STATUTORY PLANNING COMMITTEE
17 AUGUST 2009

1	314 DANDENONG ROAD, EAST ST KILDA
ADDRESS:	314 Dandenong Road, East St Kilda
PROPOSAL:	To amend an existing permit for a four storey building. Proposed amendments include external alterations, changing the ground level car park to dwellings and relocating the car parking to a basement with a resultant increase in dwelling numbers from 11 to 15
WARD:	Carlisle
NEIGHBOURHOOD	East St Kilda
TRIGGER FOR DETERMINATION BY STANDING COMMITTEE:	More than 15 objections
APPLICATION NO.:	1221/2002/B
APPLICANT:	Terry Harper Architects
EXISTING USE:	Vacant dwelling
ABUTTING USES:	Residential
ZONING:	Residential 1
OVERLAYS:	Nil
STATUTORY TIME REMAINING FOR DECISION AS AT DAY OF COUNCIL	Expired
RESPONSIBLE MANAGER:	George Borg, Manager, City Development
AUTHOR:	Phillip Beard, Senior Planner

BASEMENT PLAN
 PROPOSED RESIDENTIAL DEVELOPMENT
 314 DANDENONG ROAD, ST KILDA EAST.
 PROJECT 08-04 DRAWING NO. TP 01
 DATE 13/10/08
 TERRY HANDEEN ARCHITECTS
 14 Road, St. Kilda, Victoria 3182
 TEL: 9593 1333 FAX: 9593 1334

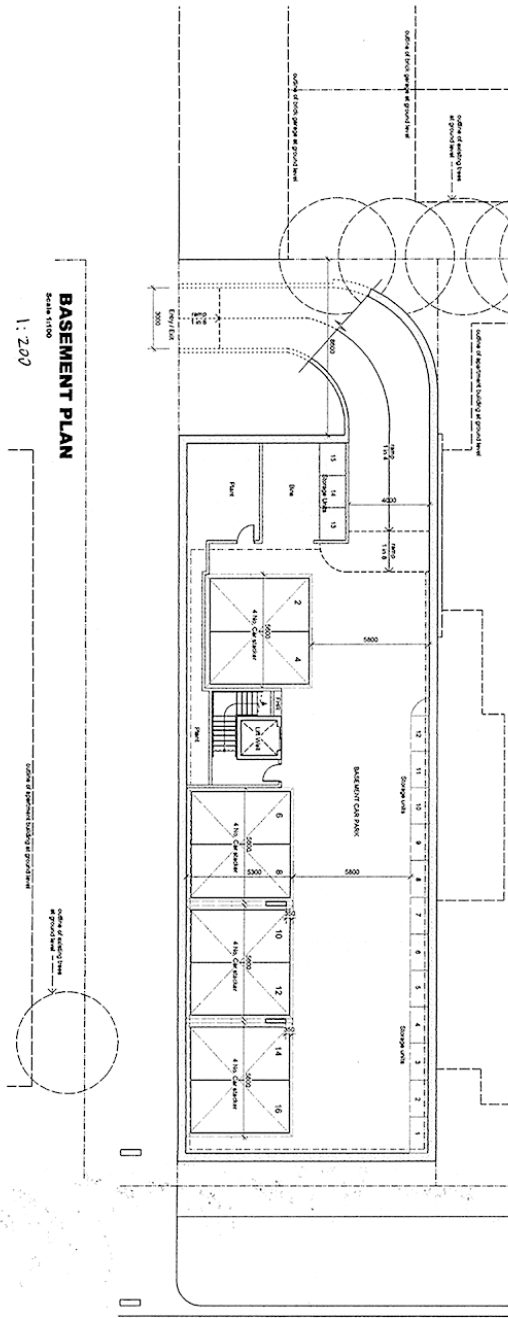
- 3.2. The current approved plans do not show a basement level. It is proposed to create a basement car park to contain the majority of the car parking for the site, along with bin storage, plant and equipment areas and storage units. This level would contain 16 car spaces in the form of pit-type car stackers, giving independent and individual access to each car space.
- 3.3. The basement would be accessed from a ramp at the southern end of the site where the abutting Right-of-Way is approximately 4.5m to 4.7m wide. The basement level would abut most site boundaries, but would be setback approximately 1.2m from the front boundary.

The applicant has offered two 5,000 litre rainwater tanks along with a dedicated bicycle storage area in the basement. This offer should be accepted. Refer proposed condition 1(b).

- (a) The building lowered by 180mm so as to have a maximum height not exceeding 47.0m AHD from natural ground level.
 - (b) The basement plan to depict provision of bicycle storage, including details of racks, and two 5,000 litre rainwater tanks.

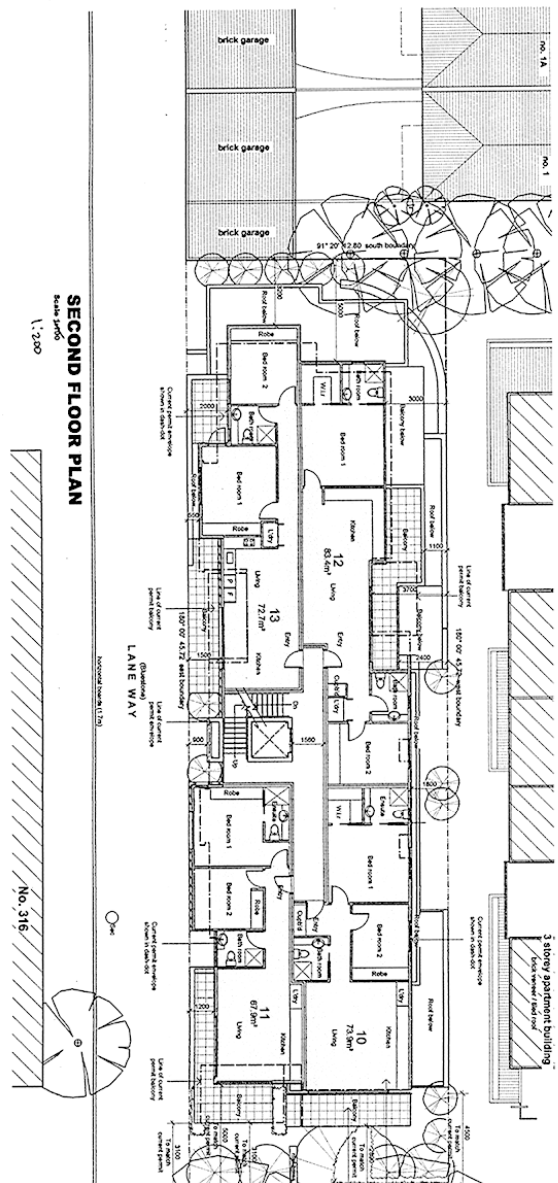
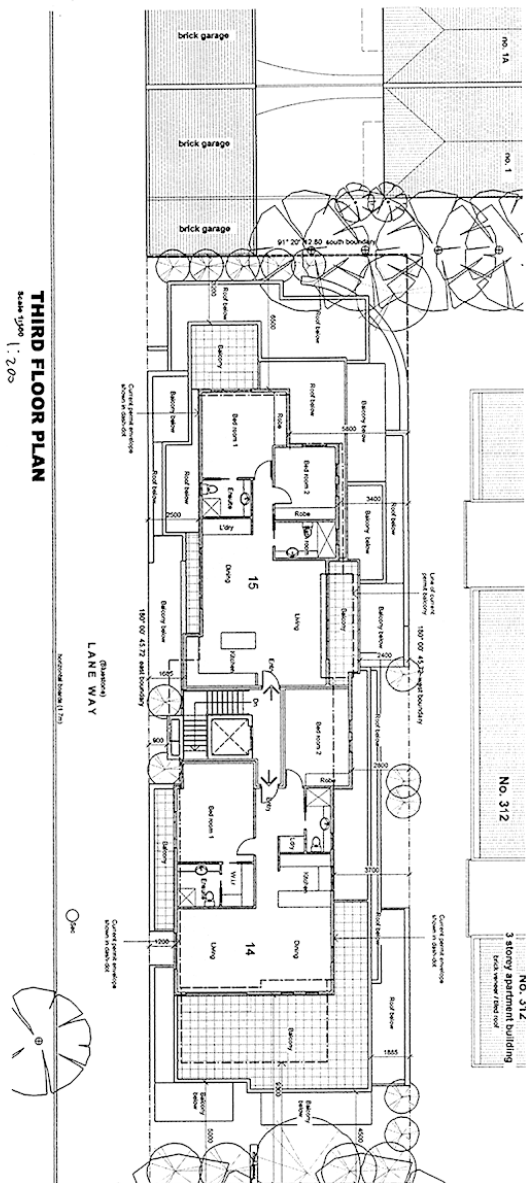
- 3.11. This level would continue to contain four x two bedroom dwellings. The front setback to the balcony would be unchanged at 2.9m and 3.1m, whilst one section of the main wall on the front elevation would be 1m closer to Dandenong Road that is, five metres compared to the current six metres. This would result in one of the front balconies being slightly smaller than currently approved.

- 3.15. This level would continue to contain two x two bedroom dwellings. The front setback to Dandenong Road to the balcony would be reduced by 1.4m to 4.6m at its closest point. The front main wall would be between approximately 200mm and 600mm closer to the boundary.

The additional width of the balcony is not considered of concern, but its reduced setback is considered to have an impact on overlooking potential. As with the proposed balcony immediately below, it is considered reasonable that the balcony screen have its battens arranged so as to achieve zero transparency. Refer proposed condition 1(f).

The setback to the front balcony face from Dandenong Road would be reduced by 1.4m to 4.6m at its closest point. Whilst not resulting in direct impact on amenity, this may have a negative impact on neighbourhood character and the streetscape presentation of the building. It is recommended that this balcony face have a minimum front setback of 6m, being that of the current approval. Refer proposed condition 1(c).

A central balcony on this side of the building continues to form part of the proposal in a very similar location and of a very similar size compared to the current approval. The most notable change would be a relatively large 'return' of the front balcony to the west face at the north-west corner of the building. The balcony would be setback 1.9m from the boundary and whilst depicted with 1.7m translucent glazing, is considered to add unnecessarily to the bulk of the building. It is recommended that this section of balcony be deleted. Refer proposed condition 1(c).

Where facing the laneway and the rear boundary, this level would be at virtually identical setbacks to that currently approved. However, a new balcony to the south-east corner of the building is proposed with a setback of 3.2m from the rear boundary. This balcony would be approximately 11m² in area. Whilst fully screened, given that this balcony would be at third level, it would undesirably add to the mass of the building and detrimentally affect outlook from the neighbouring open space to the south. It is recommended to be deleted. Refer proposed condition 1(e).
